25 November 2015

Our Ref: R/2015/19/A

RE: SSD 7064, Mixed Use Hotel, Residential and Retail Development, 175-177 Cleveland Street and 1-5 Woodburn Street, Redfern

Figure 1: Building envelope recommendation

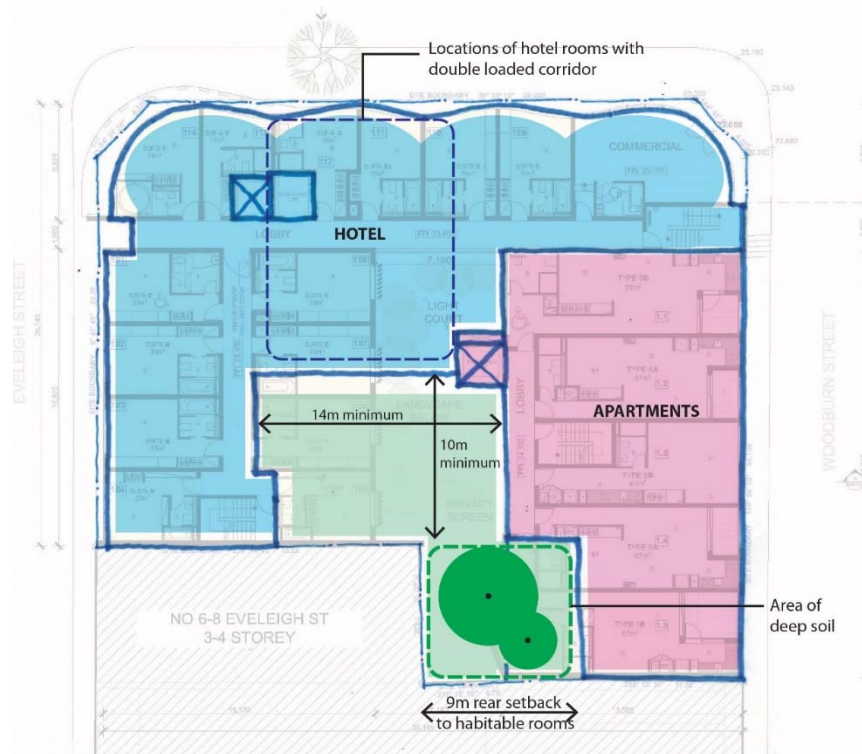
The proposal has windows from the hotel facing the gallery access of the apartments, which are separated by a 7m wide 'light court'. According to the Apartment Design Guide (ADG), an 18m wide light well is required for a building of this height. The proposal attempts to mitigate the insufficient separation between the hotel and the apartments by providing screening to the hotel rooms, however the ADG states that building separation is also required to ensure an appropriately scaled relationship between buildings.

There is also a 4.5m rear setback to the southern part of the site from the existing apartments at 6-8 Eveleigh Street. The ADG recommends a 9m setback to rear and side boundaries for habitable rooms and 4.5m to non-habitable rooms. At ground level, the bedroom window faces the rear boundary and above this the bedroom has an angled window to try and overcome the insufficient setback from the rear boundary. This strategy of an angled window is inconsistent with the ADG, which requires that: *'A window should be visible from any point in a habitable room.'*

To address these issues the City recommends that the applicant should consider making the double loaded corridor arrangement to Eveleigh Street a single loaded corridor and relocate the double loaded corridor to Cleveland Street. This would ensure sufficient separation is provided between the uses assuming that there will be corridors of each of the uses opposite each other. It is estimated that the above recommendation would result in the loss of one hotel room per floor on Levels 2-6. In addition, the setback from 2-6 Eveleigh Street should be increased to 9m and privacy improved by provided an area of deep soil suitable for tree planting. The above recommendations are illustrated in Figure 1 below.

the location shown in Figure 1 above, this could be used to plant a mature tree, which would provide screening and outlook for the benefit of future residents.
